CUYAMA BASIN GROUNDWATER SUSTAINABILITY AGENCY STANDING ADVISORY COMMITTEE

AGENDA

November 29, 2018

Groundwater Sustainability Plan Update

Figure 2.2-28: 2008-2018 Average Well Measurements of Arsenic, ug/L

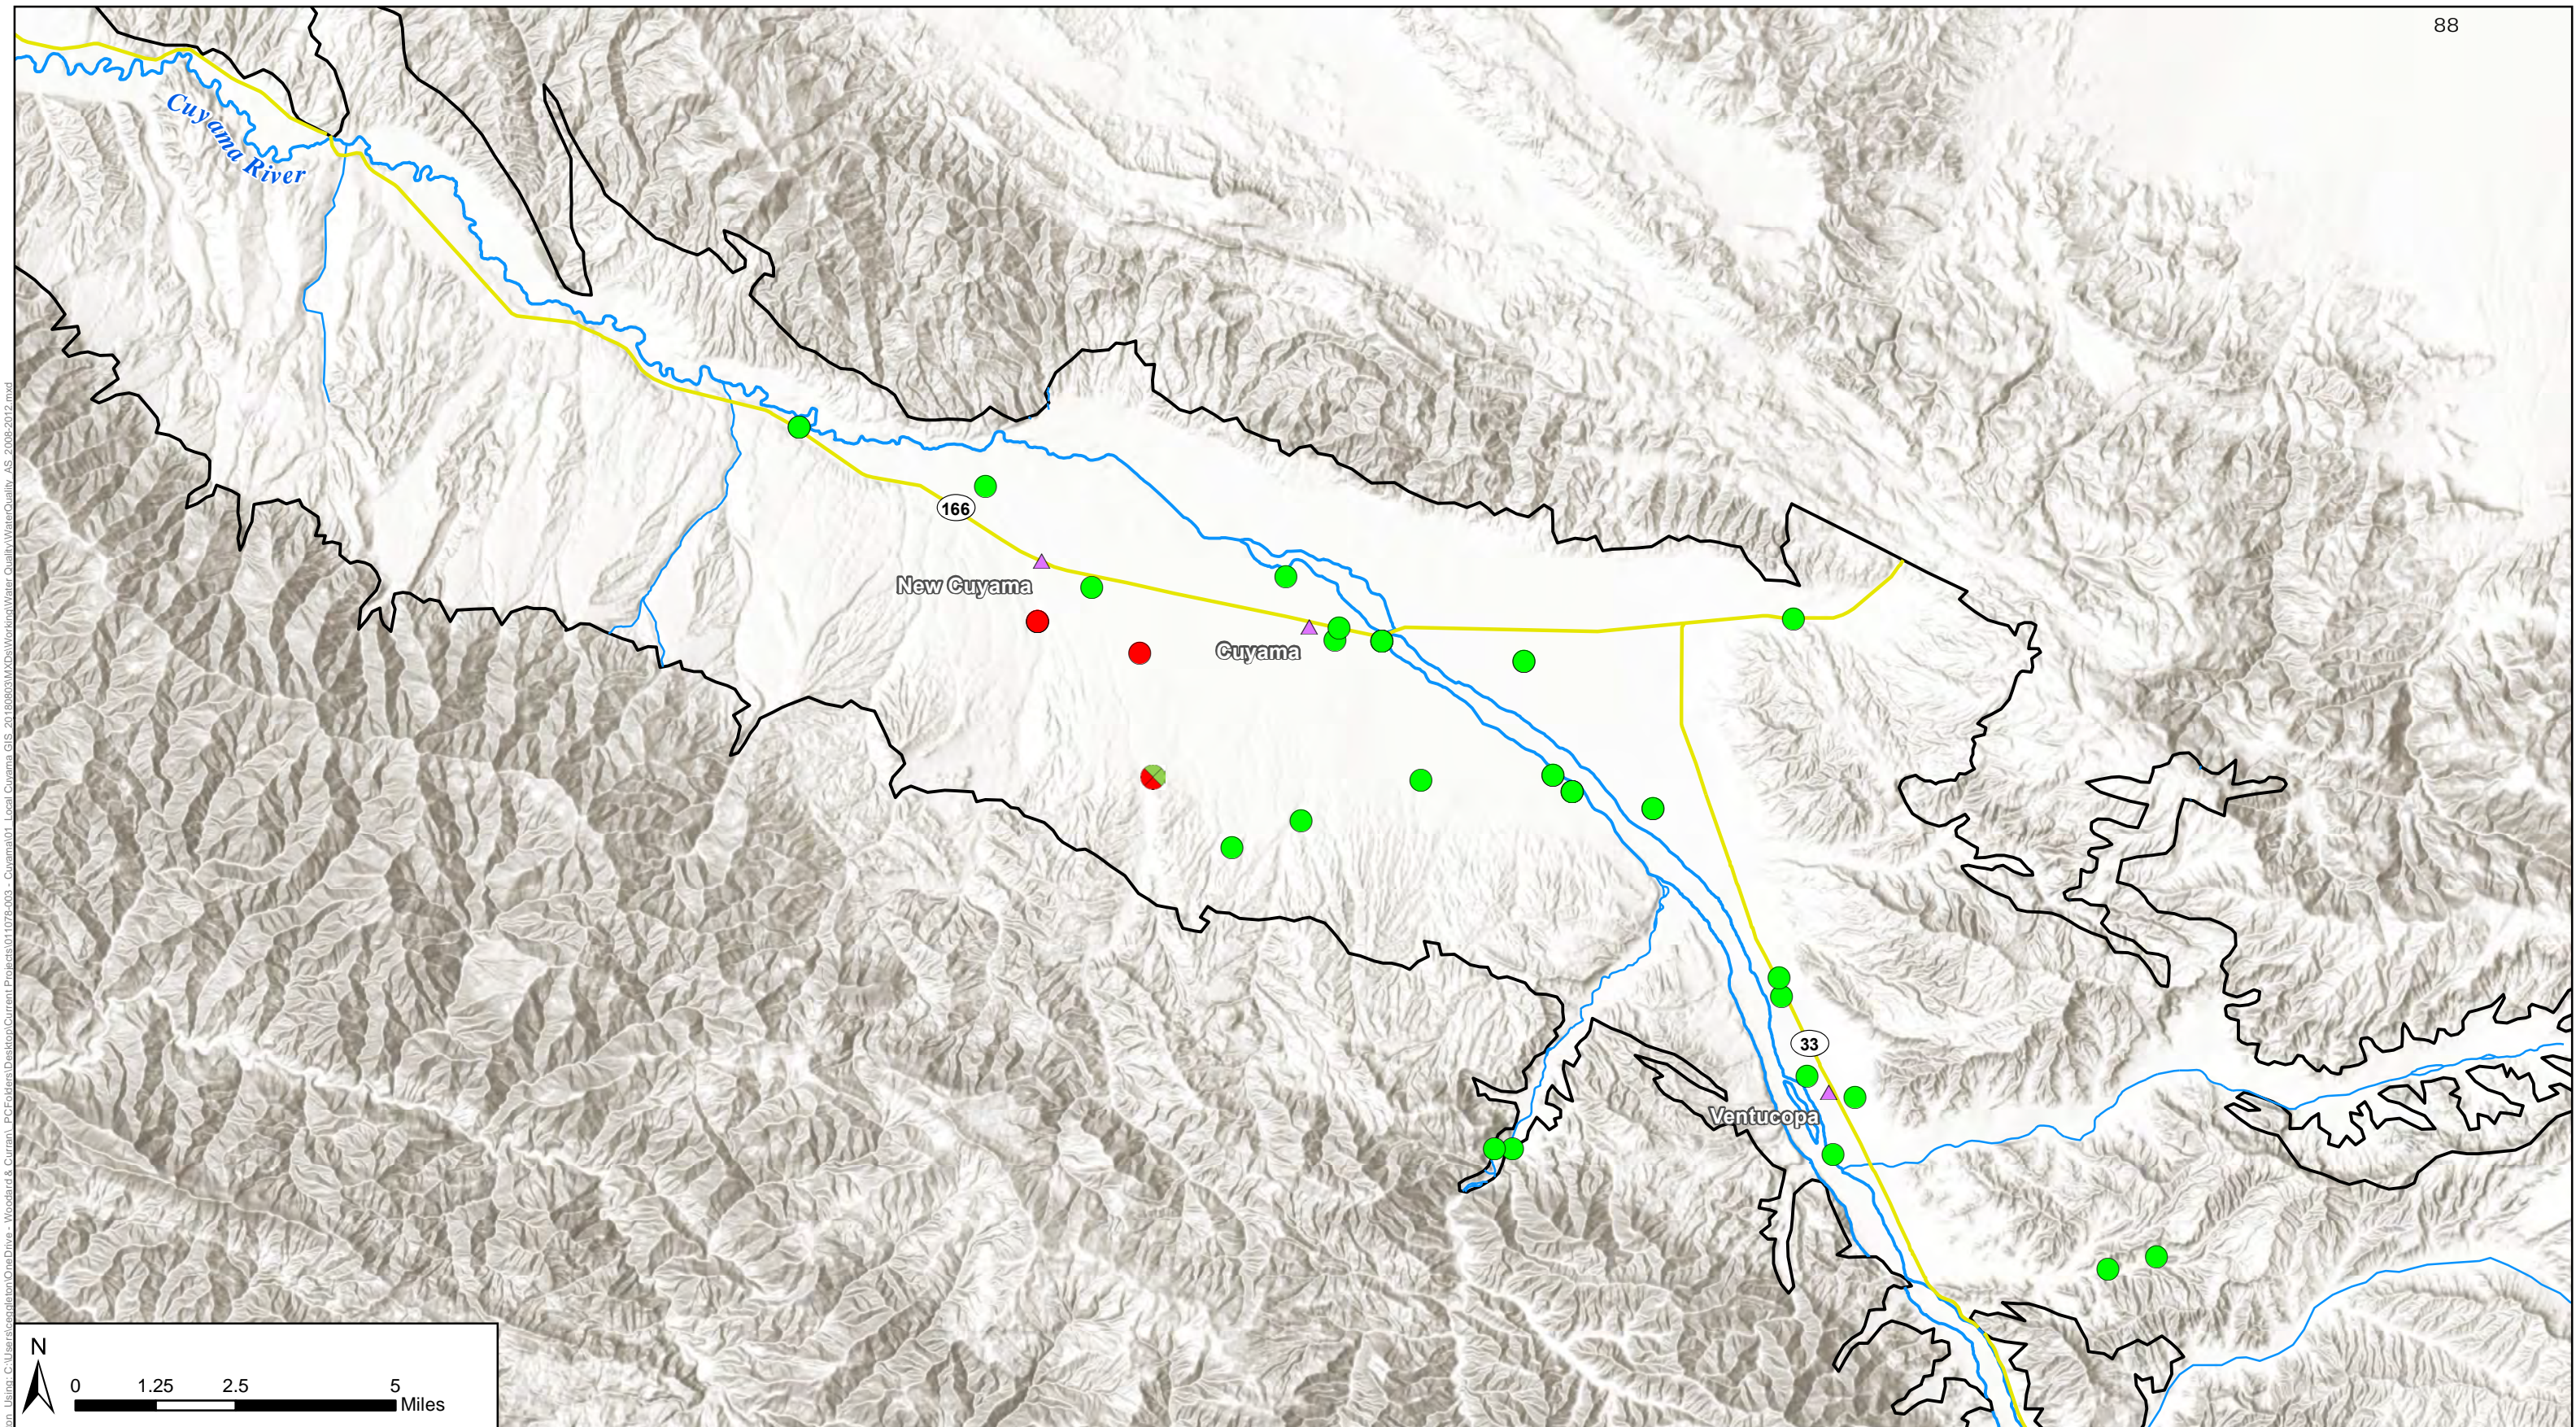
106	Cathy Martin	County of San Luis Obispo	2.2.7 Data Analysis			Figure 2.2-28 shows that the	Figure 2.2 28 shows arsenic measurements from 2008-2018. Data was not available prior to this time period in significant amounts. Figure 2.2 28 shows arsenic measurements were below the MCL of 10 ug/L where data was available. Suggest adding number of samples, ## samples out of ### total samples	Text has been revised for clarity.
107	Cathy Martin	County of San Luis Obispo	Figure 2.2-31				Place label on figure (Ballinger, Quatal, and Apache Canyons)	These are labeled on Figure 2.2-1
108	Cathy Martin	County of San Luis Obispo	2.2.7 Literature Review	Bullet List		97% of samples had concentrations greater than	Is this the MCL for each concentration? If so, please add the MCL in the bullet point	These are not the MCL. No change needed.
109	Matt Young, Matt Scrudato, & Fray Crease	Santa Barbara County Water Agency	General				This section as a whole requires significant revision. The description of wells needs to be revised to be clear what entity conducted the monitoring, not what database W&C gathered the data from. For a discussion of SBCWA monitoring programs in the basin, the SBCWA contract with the USGS, and its relationship to CASGEM, please contact Matt Scrudato. This section contains minimal analysis of groundwater conditions, just reporting of selected hydrographs, with little explanation or interpretation. The water quality section is confusingly structured and incomplete. Finally, although we understand the time sensitivities in preparing the GSP by spring 2019, it would save reviewers quite a bit of time if a technical editor or senior W&C staff member reviewed these sections prior to distribution.	The section has been revised for clarity.
